**DATE:** December 13, 2023

<u>Certificate of Appropriateness Request:</u>	H-15-22
<u>Applicant:</u>	Jim Potter/Old Towne Development
<u>Location of Subject Property:</u>	68 Cabarrus Ave W
<u>PIN:</u>	5620-87-0595
<u>Staff Report Prepared by:</u>	Kim Wallis, AICP, Senior Planner

**DATE:** November 8, 2023

<u>Certificate of Appropriateness Request:</u>	H-15-22
<u>Applicant:</u>	Jim Potter/Old Towne Development
<u>Location of Subject Property:</u>	68 Cabarrus Ave W
<u>PIN:</u>	5620-87-0595
<u>Staff Report Prepared by:</u>	Autumn James, Planning & Development Manager

EXHIBIT C

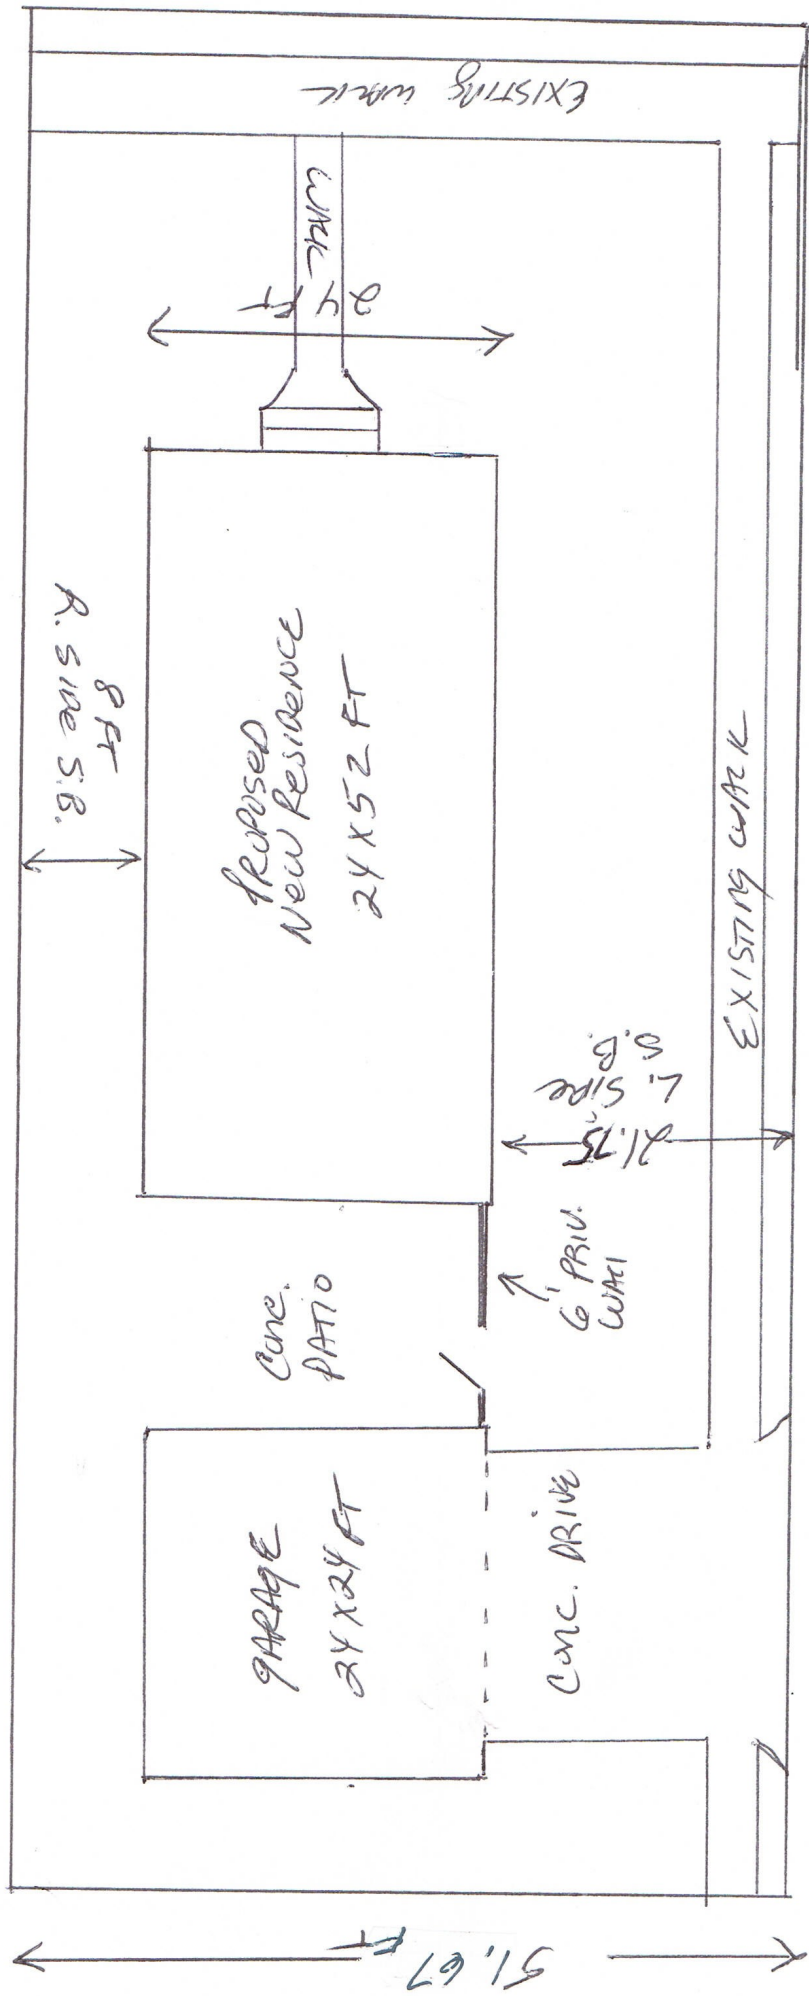
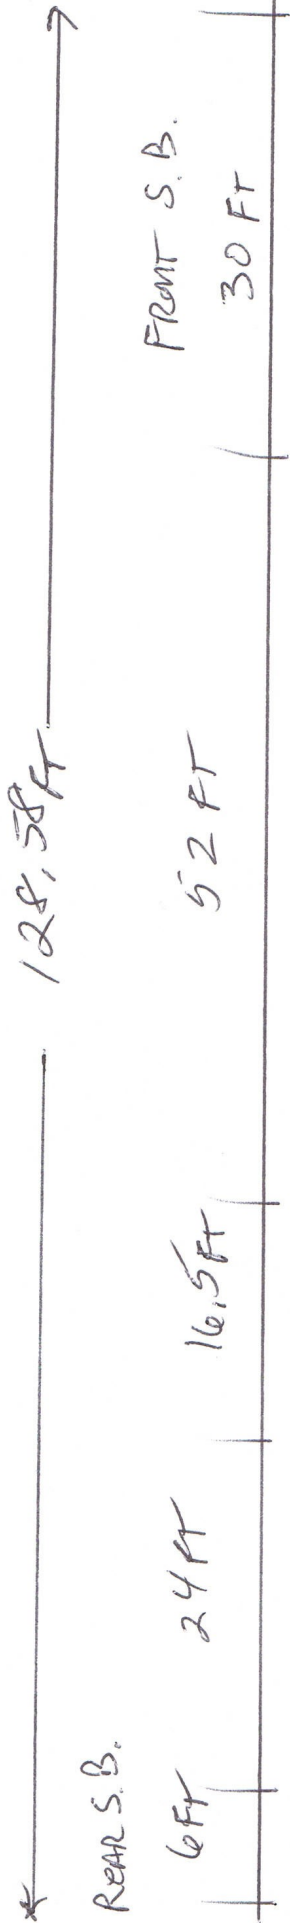
- On November 8, 2023, this case was reviewed by the Historic Preservation Commission (HPC) and continued to the December meeting in order to receive a landscape plan from the applicant to show the following: the placement of the two replacement trees and the landscaping planted along the proposed privacy wall, intended to hide it from view it within two years.

The applicant has submitted a landscaping plan showing existing trees to remove and to remain, and the required replacement trees and screening shrubs as recommended by Bill Leake, City Arborist, which include: a canopy tree (Oak) in the right side front yard, a canopy tree (Maple) and an ornamental tree (Crape Myrtle) in the left side yard near the sidewalk along Yorktown St., ten (10) screening shrubs (Ilex Holly) along the left side of the house and privacy wall, and four (4) foundation shrubs (Camellias) in the front yard landscaping bed (Exhibits C, and D).

68 CABARRUS AVE W - ILEX HOLLY SCREENING SHRUB – MATURE SIZE – 36 IN WIDE – 5 FT HIGH

68 CABARRUS AVE W.  
LEFT ELEVATION

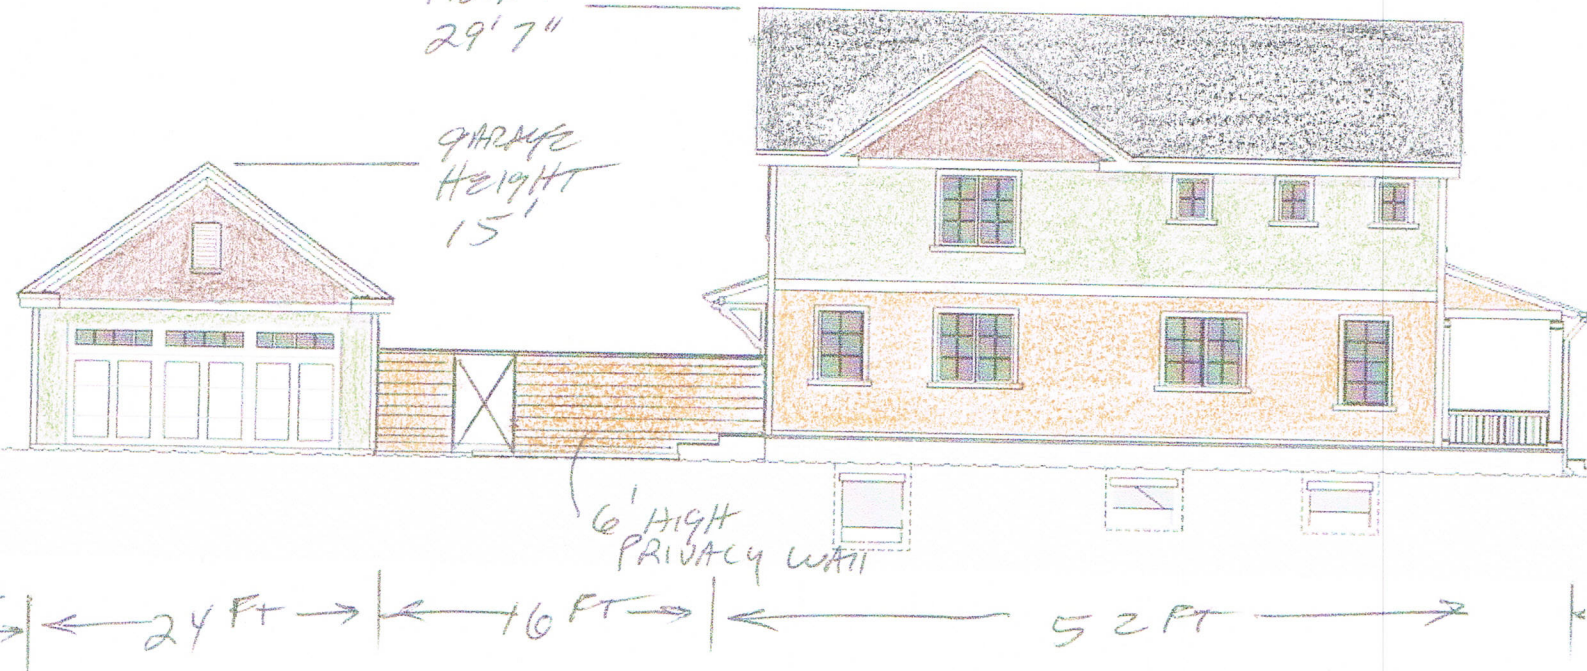
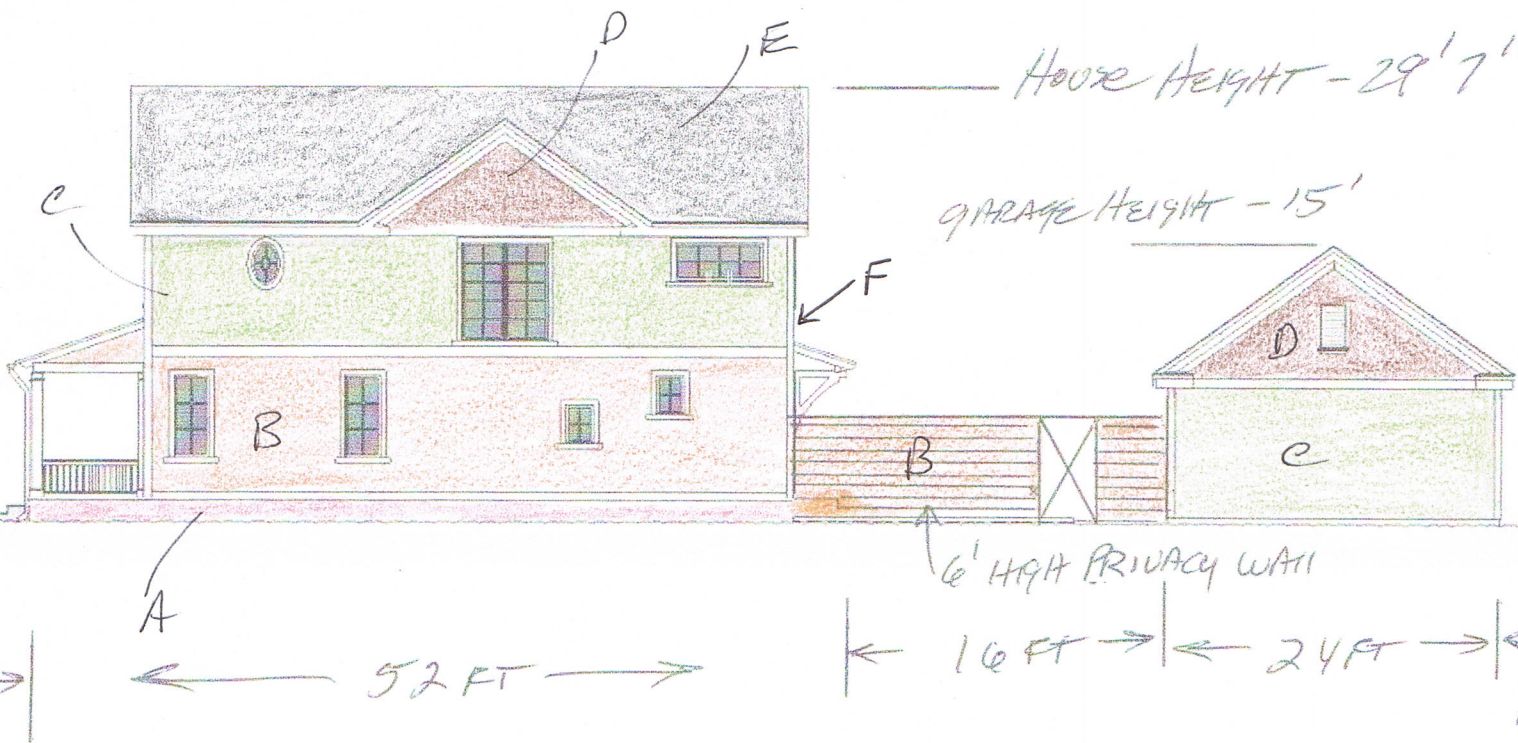
The applicant has also updated his proposal based on the comments at the November 8, 2023 HPC meeting to include the following revisions: a change in window material from aluminum clad to wood for all elevations, a three (3) foot wide concrete walkway that will extend from the front steps to the public sidewalk in the front yard, and a change in color of the lap siding in the gable from Chestnut Brown to Timber Bark (Exhibits B, E, and F).

6' HIGH  
PRIVACY WALL
